Certificate of Appropriateness
BAR #25-0079
759 Belmont Ave, TMP 580172000
North Downtown ADC District
Owner: Viewmont Associates LLC
Applicant: Dan Bracey on behalf of Elaine Oakey
Project: Chimney removal

**City of Charlottesville
Board of Architectural Review
Staff Report
May 20, 2025**

Certificate of Appropriateness Application

BAR #25-0079

EXISTING CONDITIONS

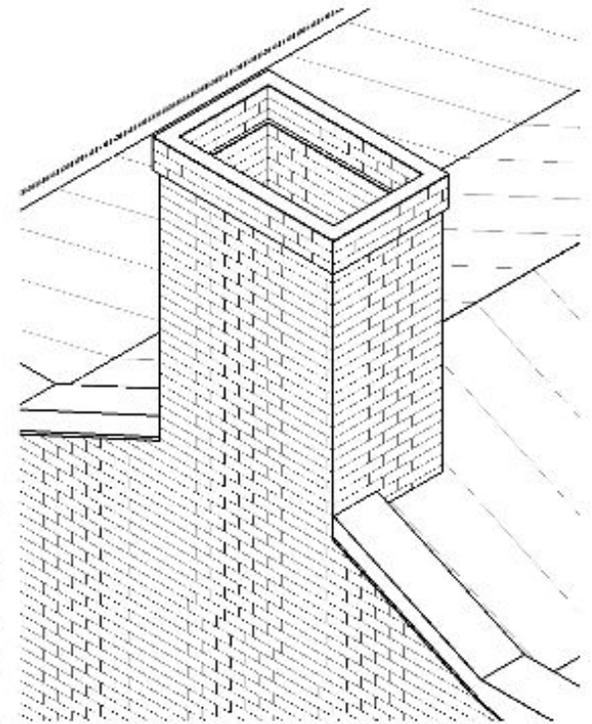
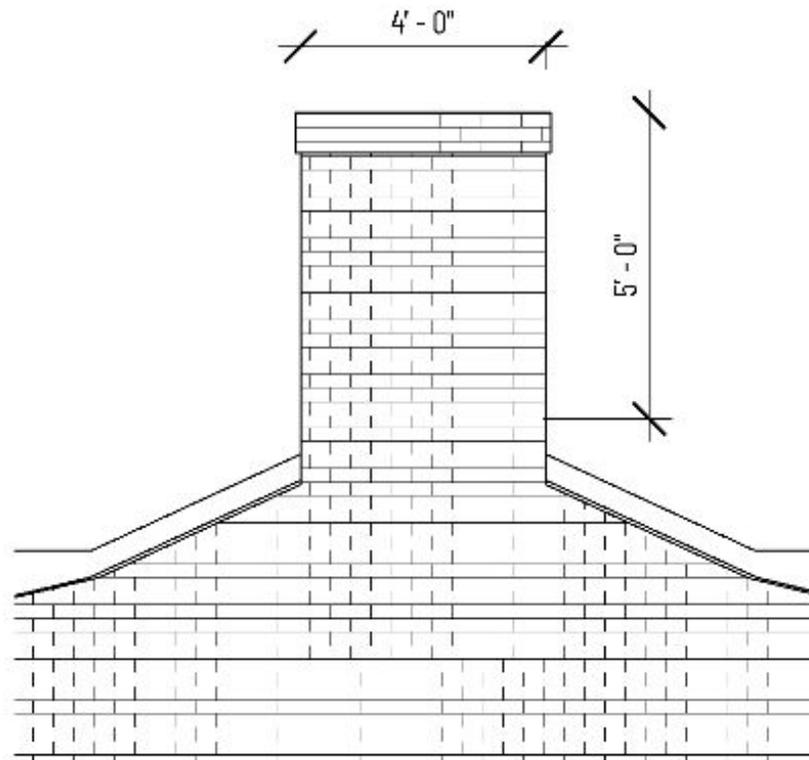
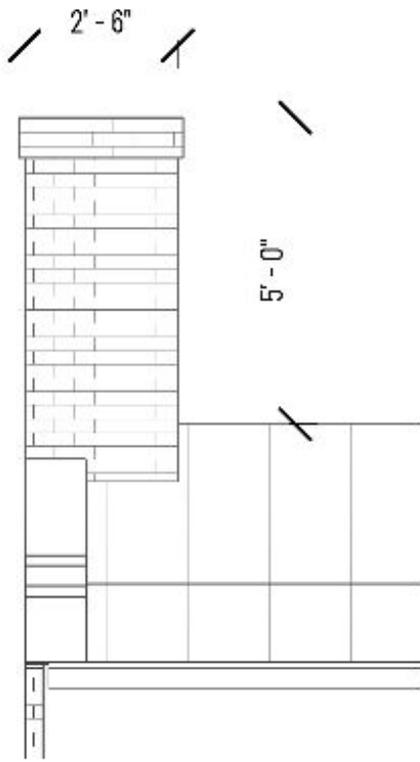
My assessment of the chimney in question is that it is in very poor condition. The mortar joints have no structural integrity at this point and have actually turned into dust in most of the chimney causing the brick to slowly lean approximately 4 inches towards the house. It is positioned on the gable end and while there's little to no danger of the chimney falling towards the driveway, it will inevitably fall onto the roof if it is not addressed in the immediate future.

Our plan is to remove the chimney down to the peak of the gable, capping it off with a metal dome and installing vents through the dome to allow the furnace to vent properly. Our removal process will involve scaffolding up to the chimney and removing the brick onto the scaffolding and lowering them down using a rope and pulley system.

PROPOSED DEMOLITION

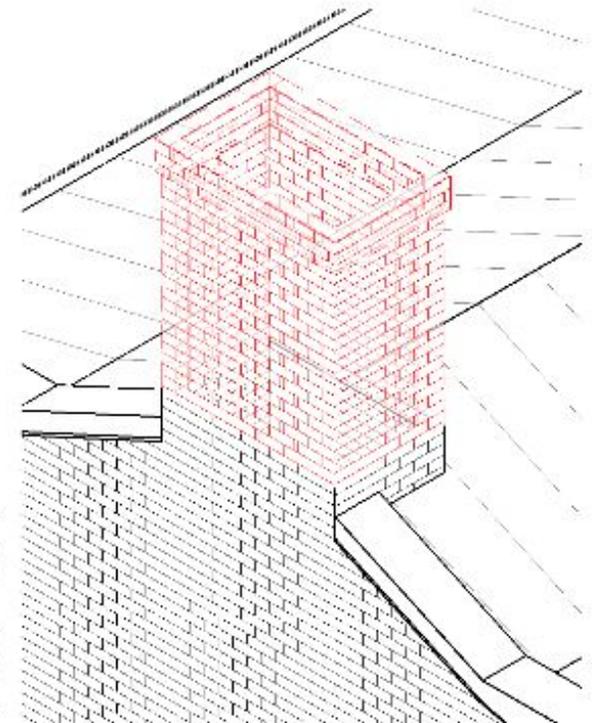
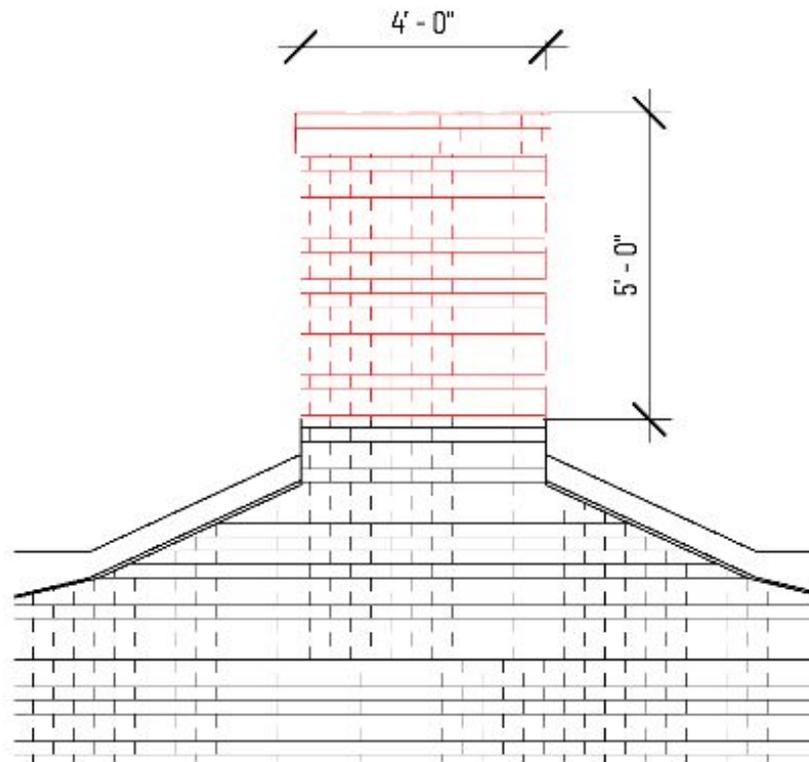
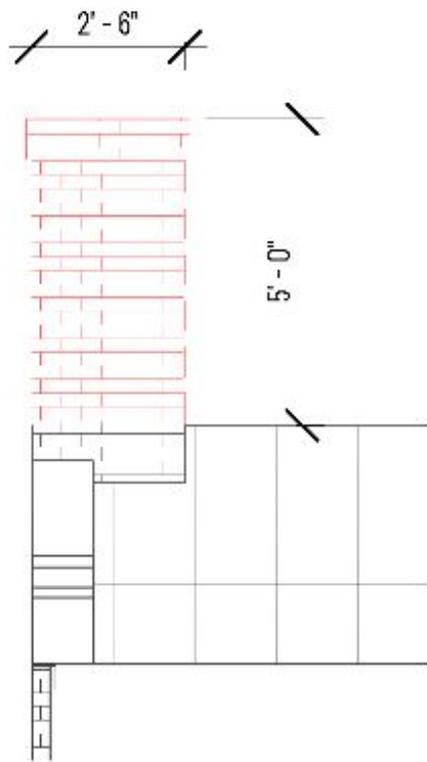
- Remove the chimney down to stable masonry [brick and mortar], then reconstruct it either reusing the historic bricks, with appropriate mortar, or using new brick. The stability of masonry below the roof line is not known.
- Document the chimney with photographs and dimensioned sketches, to be submitted for the BAR archive. Remove the chimney down to the parapet. Repair/repoint exposed exterior brick at the parapet, as necessary. Cap the parapet similar to the work done at the west chimney, using painted, standing-seam metal and terra cotta coping.

- Prior to removal, the east chimney will be photographed and documented, including a dimensioned sketch, such that the chimney could be reconstructed at a later date. That documentation will be submitted for the BAR archive.
- Repairs to the remaining masonry will be completed using material, mortar, and methods appropriate for early-19th century masonry.
- The standing-seam metal roof will be repaired so as to match the existing pan widths and the joints will be crimped, including the ridge.
- The parapet will be capped with terra cotta coping, similar to the repairs at the west parapet.
- The BAR encourages the owner to store on-site bricks removed from the chimney, such that can be re-used if the chimney is later reconstructed.
